**REVIEW OF SPECIAL EXPOSURE COHORT ISSUES
FOR THE HANFORD SITE FOR THE PERIOD
JULY 1, 1972, TO DECEMBER 31, 1990**

**Volume I – Main Report
Revision 1**

Contract No. 200-2009-28555

September 2011

Figure 1. B-Plant Strontium and Cesium Recovery History

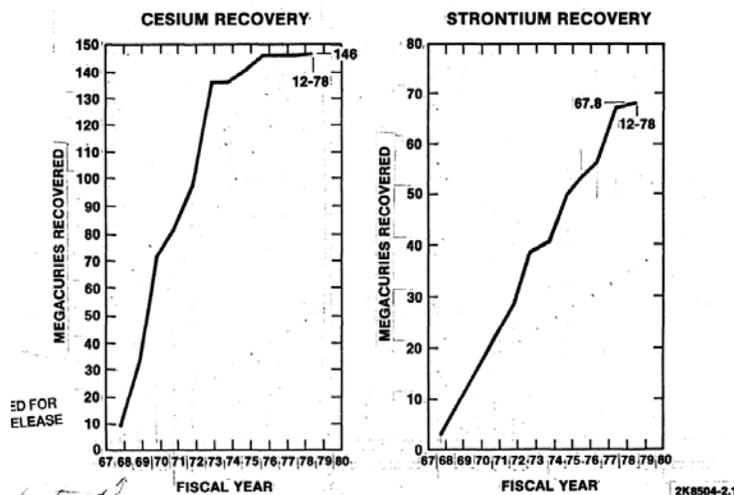
As is evident from the figure, which shows cumulative recovery, very little cesium recovery took place during the 1976–1978 period, and very little Sr-90 recovery took place during 1978. From 1974 to 1978, the recovered Cs-137 and Sr-90 were purified for encapsulation. From 1978 to November 1983, there was no separation of Sr-90 and Cs-137, but both were conditioned for

encapsulation. The cesium capsule production run ended in October 1983, and the Sr-90 capsule production run ended in January 1985 (B Plant 1985, pdf file p. 13; ORAUT 2010b, p. 16). Hence, except for the tank farms, the main exposure potential from reprocessing and Hanford high-level waste activities was to Sr-90 and Cs-137 during 1978 to 1983 period. The dates can be summarized as follows:
